**43 Barkley Circle, Suite 200
Fort Myers, FL 33907
Phone 239-433-4231 Fax 239-433-9632
www.tdmcivilengineering.com
Certificate of Authorization # 29086**

**Reference: Williams Avenue CPD
DCI2021-00014 (1st Resubmittal)**

Zoning Section Comments:

AS-BUILT SURVEY OF:

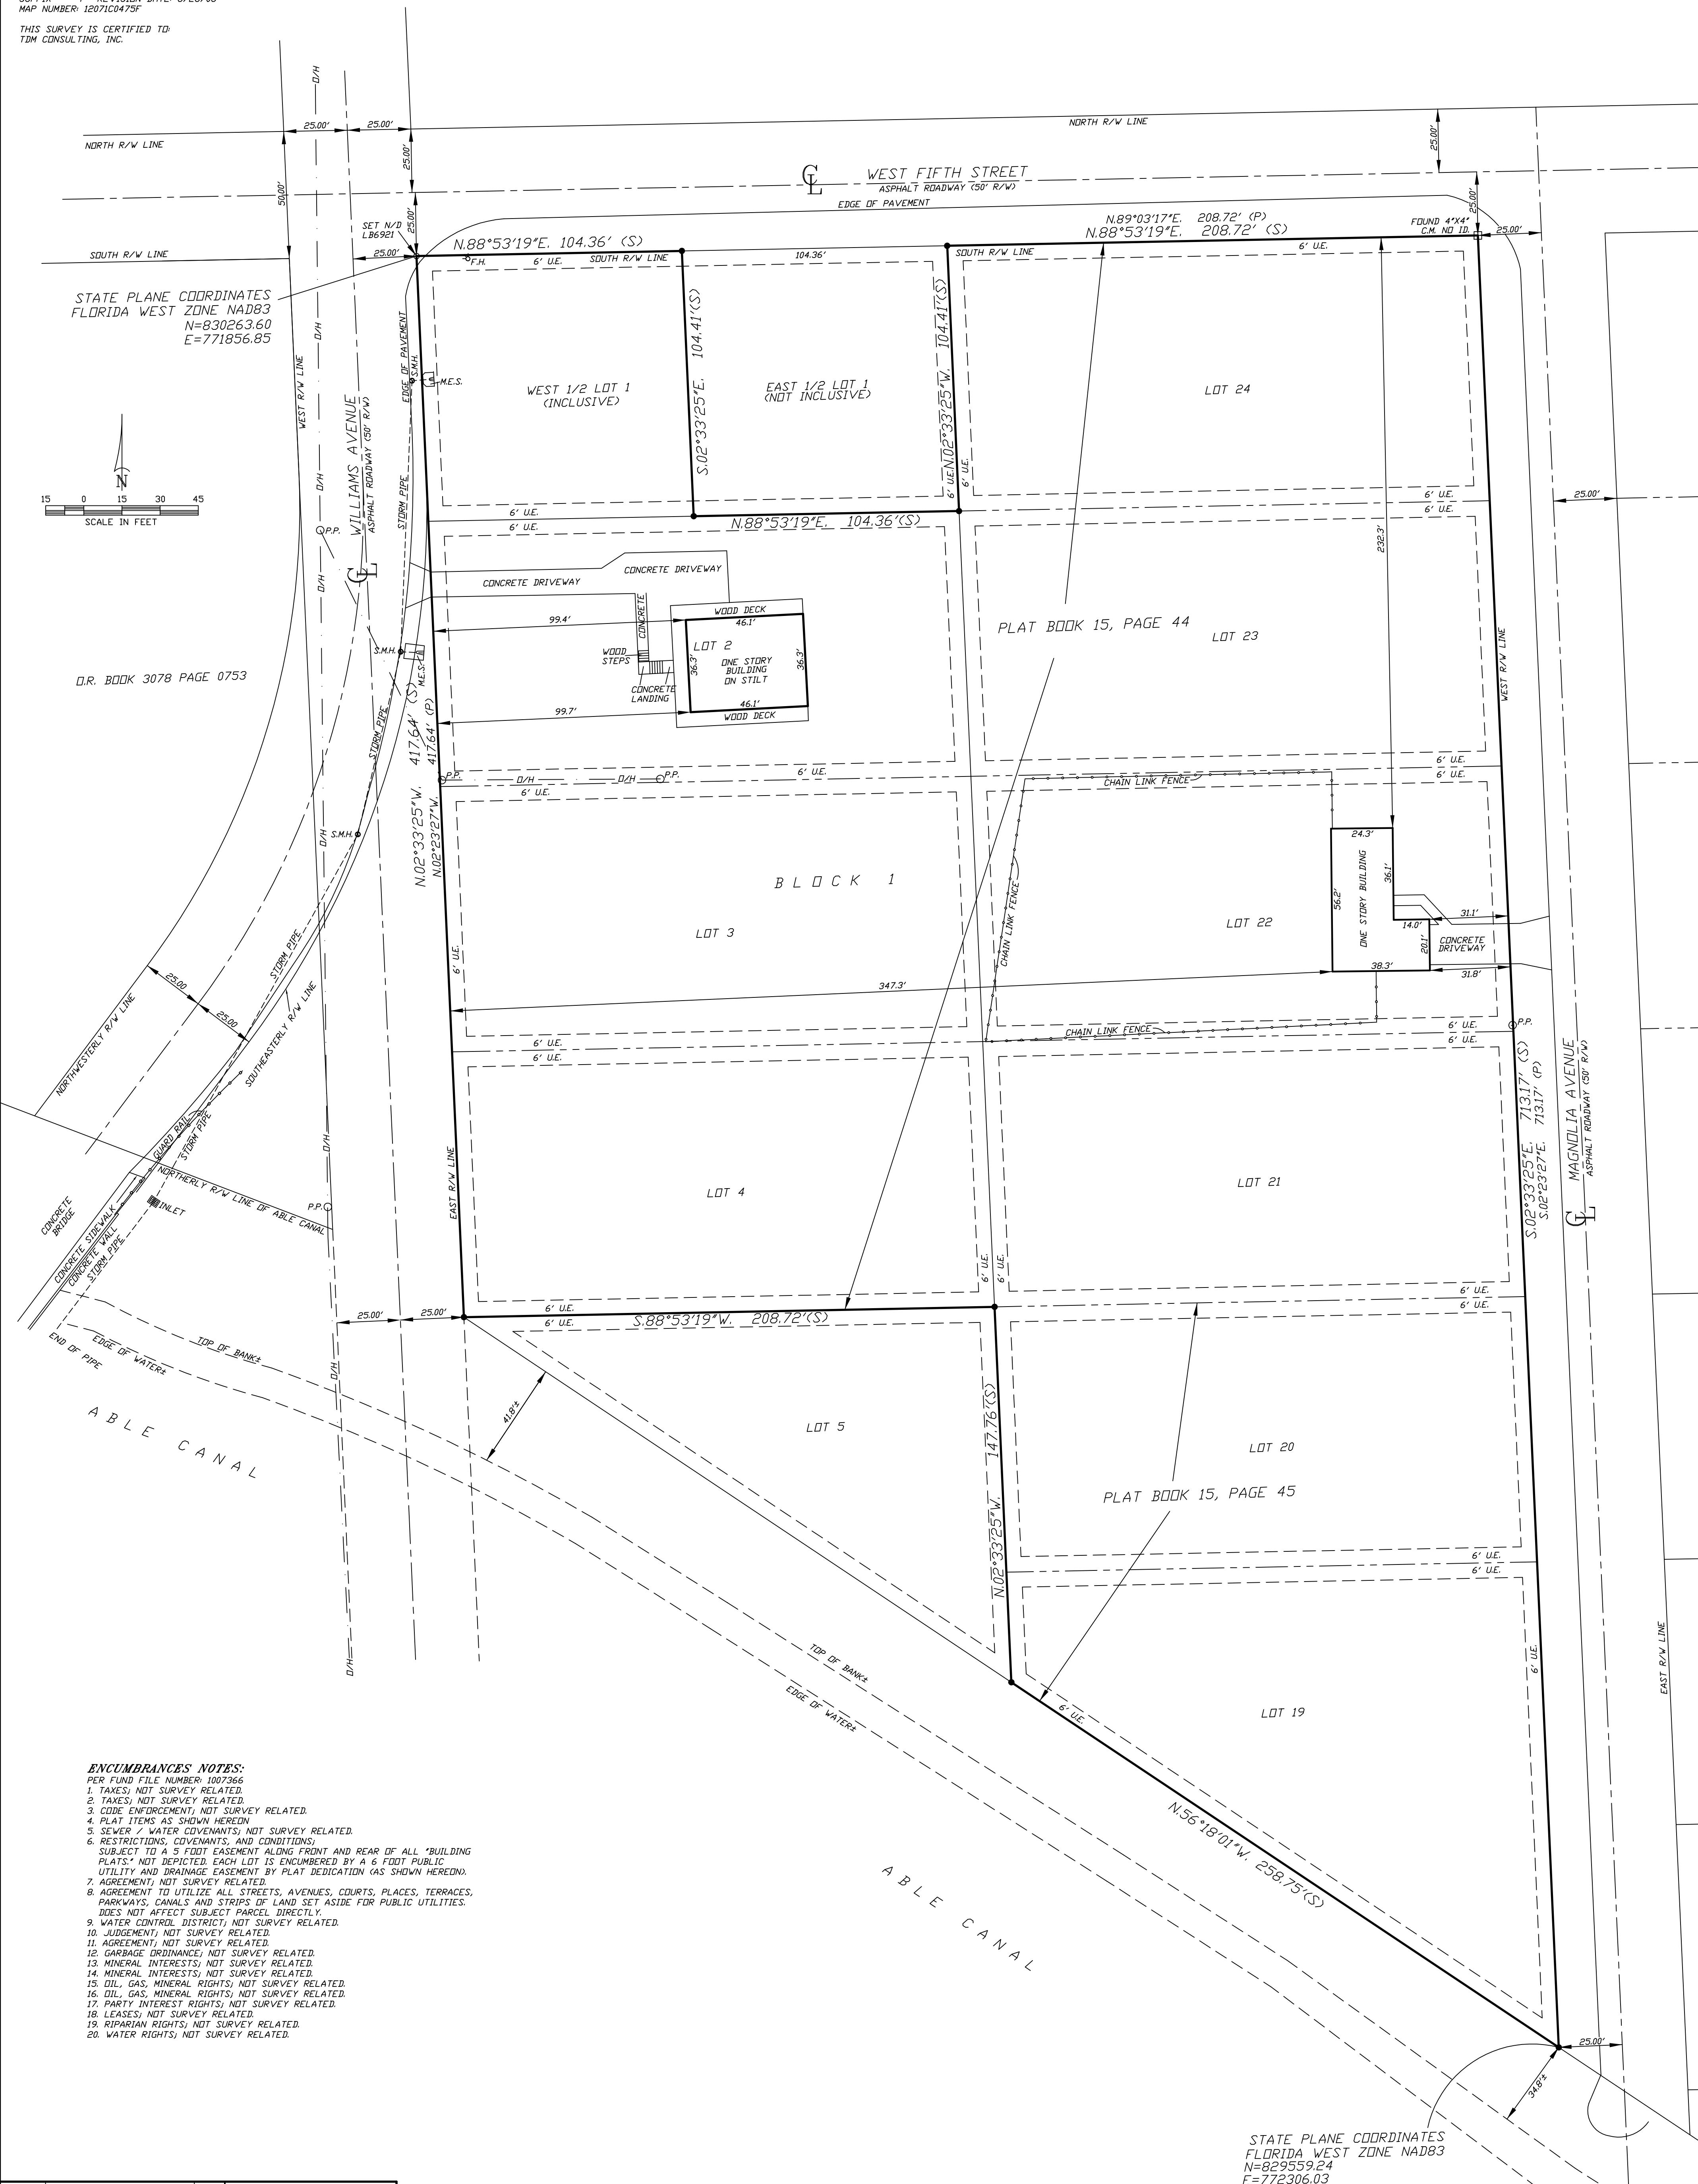
Staff Comment: Provide a boundary survey in accordance with the requirements of Lee County LDC §34-202(a).

The survey must be tied to the state plane coordinate system for the Florida West Zone (the most current adjustment is required) with two coordinates, one coordinate being the point of beginning (POB) and the other an opposing corner.

Response: Please see the revised boundary survey with the corrections as requested.

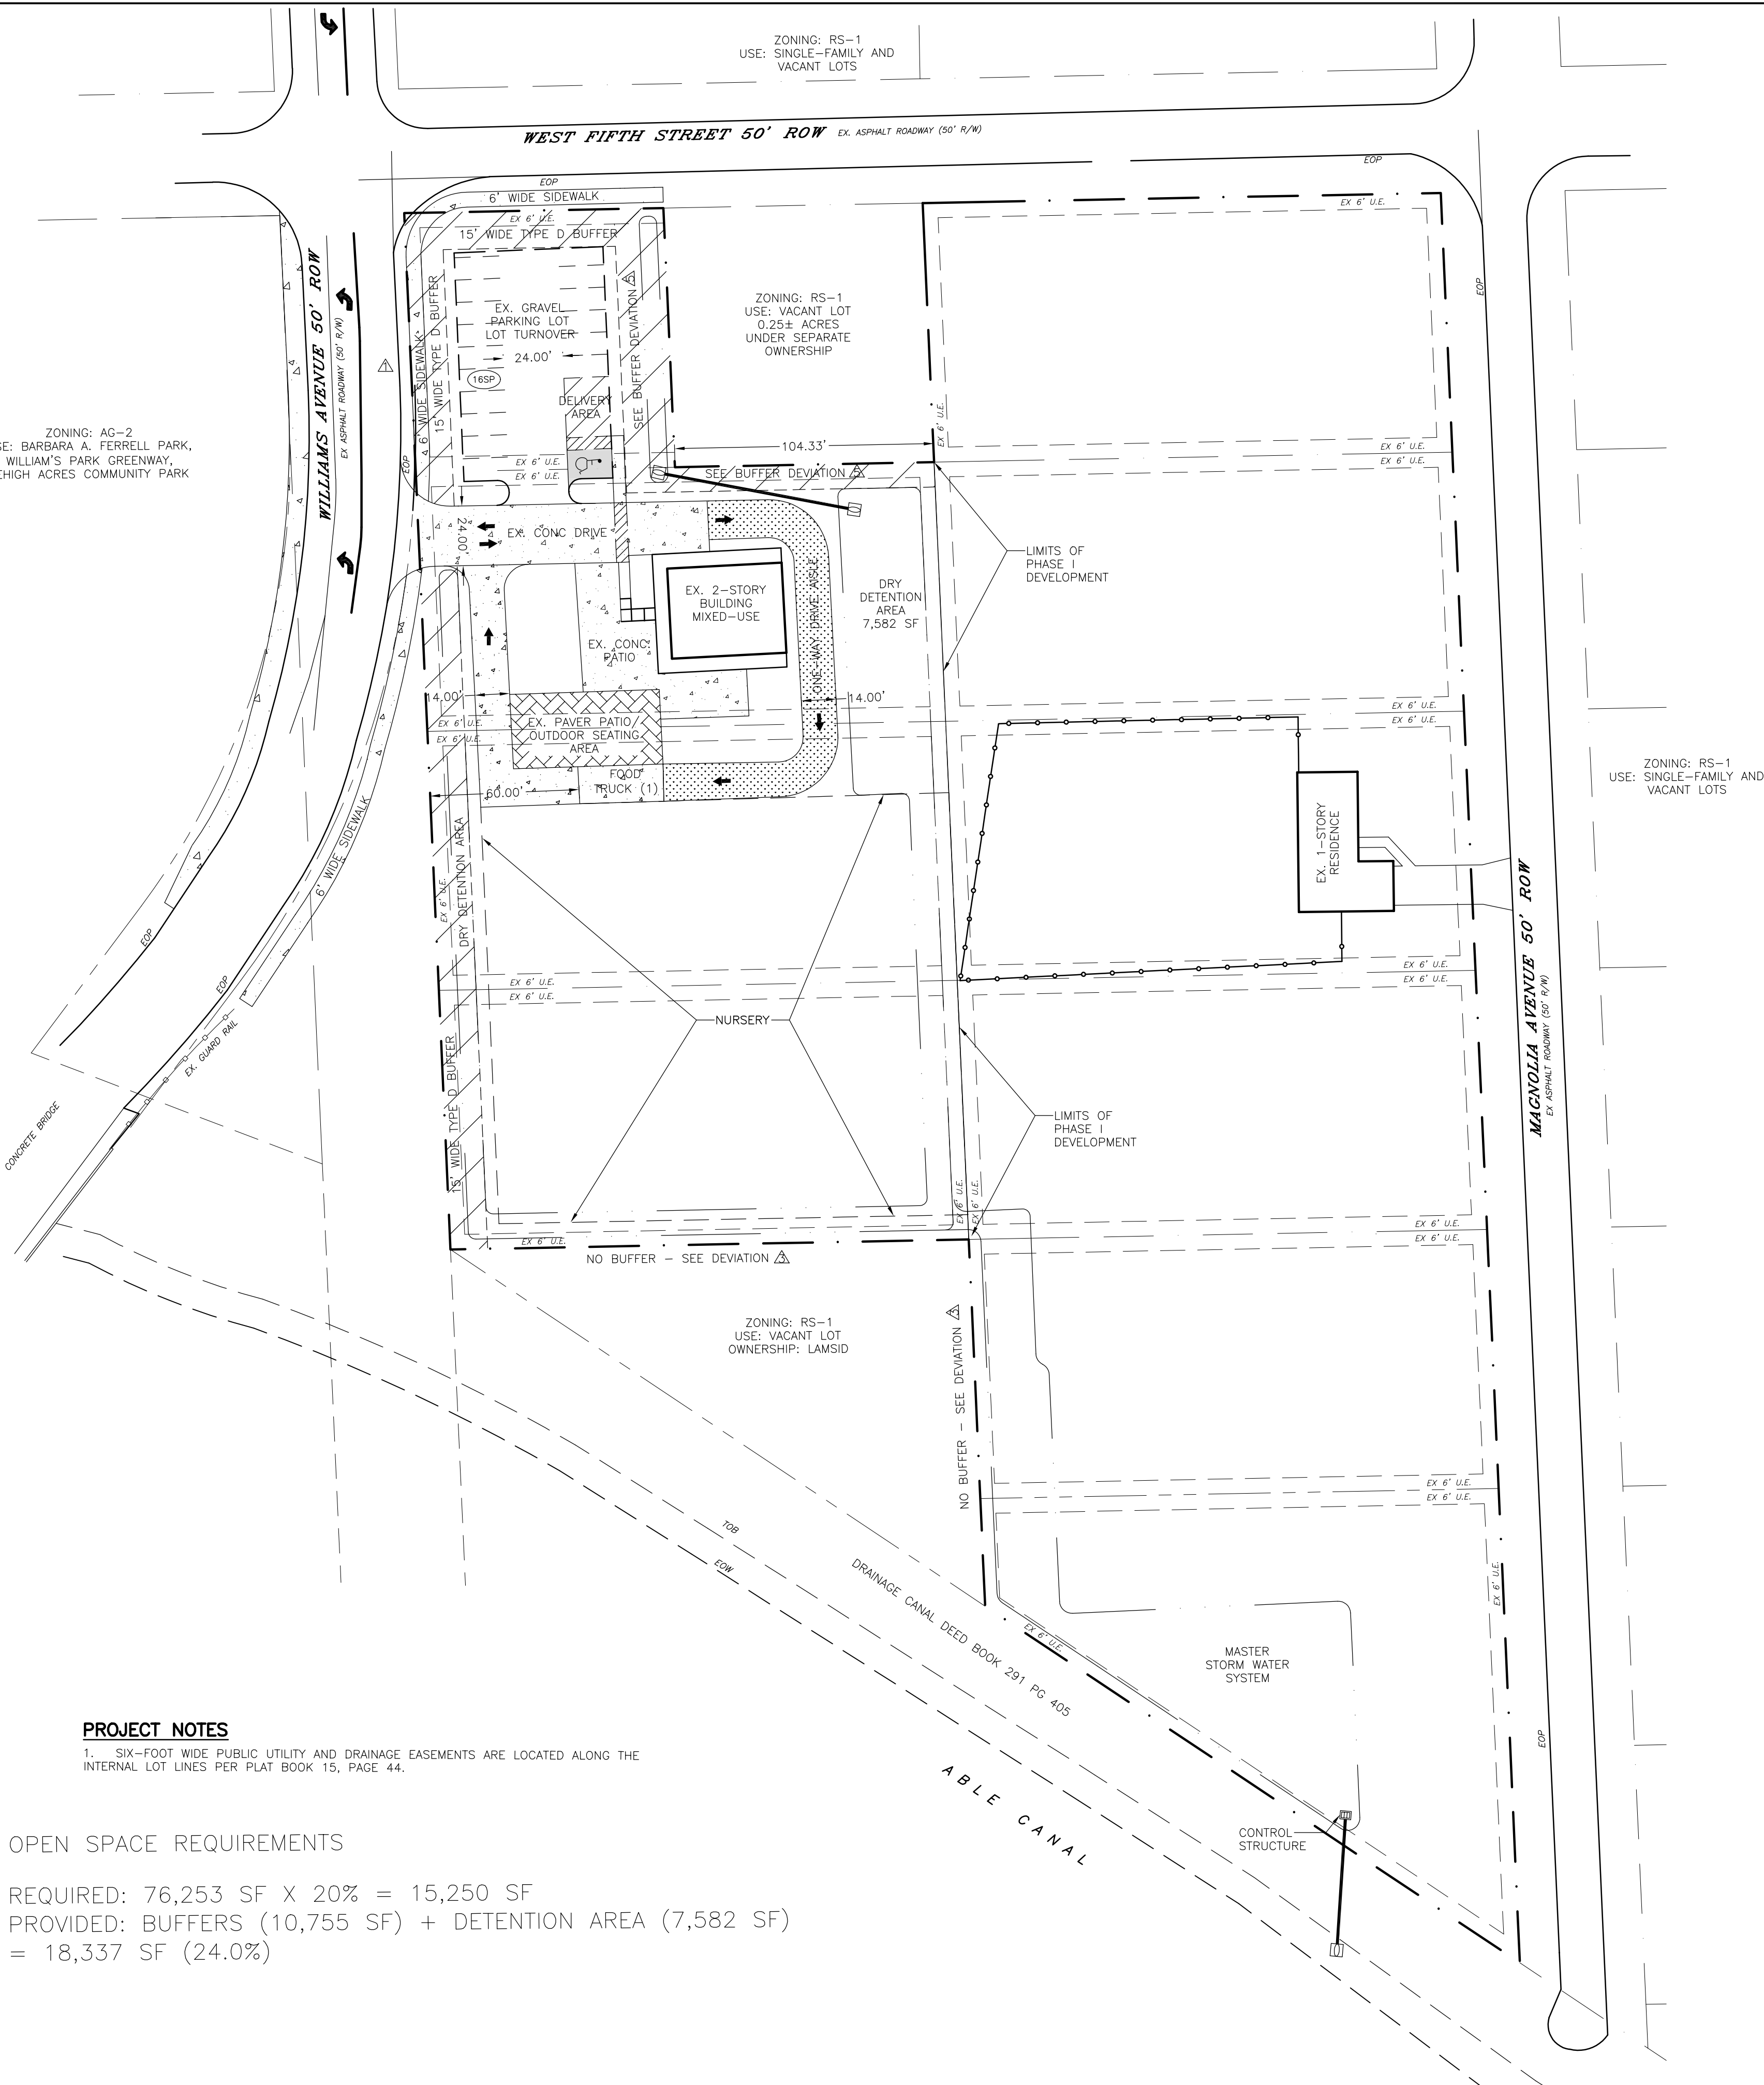
2. Master Concept Plan (MCP) – LDC Sec. 34-373(a)(6). Revise the MCP to depict:

- a. The general location of service areas for delivery of goods or services must be shown for all developments that are not residential subdivisions.

- d. The MCP depicts an outdoor seating area, please assess the total outdoor seating area, assuming it's intended for the restaurant use. Revise the parking calculations accordingly.

11. It is unclear if the detentions depicted on the MCP are wet or dry detention areas. Revise and label accordingly. If any of the detentions are wet (lake), indicate if the lake is a deep lake, if the slopes will comply with LDC Section 10-329(d) for lake excavations, and planted littoral shelf requirements in LDC Section 10-418.

Response: See the revised Master Concept Plan for the location of delivery areas as requested.

Response: See the revised parking calculations on the MCP for the outdoor seating area as requested.

Response: All detention areas are Dry Detention. Please see the revised MCP for the correction.
